Reading Conservation Area Advisory Committee
25 June 2026

COMMENTS ON APPLICATION PL/26/0620

Reading Conservation Area Advisory Committee make the following observations on this proposal to build a house on land adjacent to 1 New Road. We commented on a previous application PL/25/1471 and many of our comments are repeated below in relation to the current application.

Figure 1 Extract from OS map 1872-1877 published 1883. Courtesy National Library of Scotland. Approx site of proposed development on land adjacent to 1 New Road within area circled

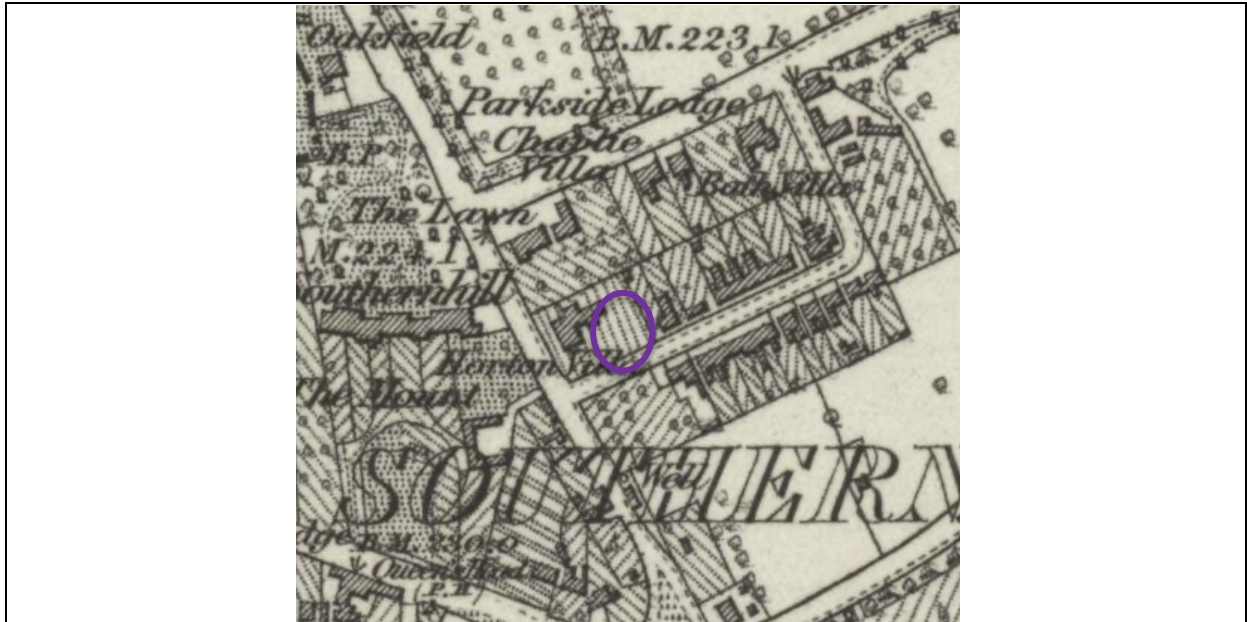
2.1 The land lies within character area 1 of the Redlands Conservation Area (CA) and was once part of the garden of 17/19 Redlands Road. In this respect it is unlike land adjacent to 43 Upper Redlands Road (PL/25/0620) where a significant part of the site was a historically undeveloped plot as can be seen in the extract from the 1883 Ordnance Survey map below.
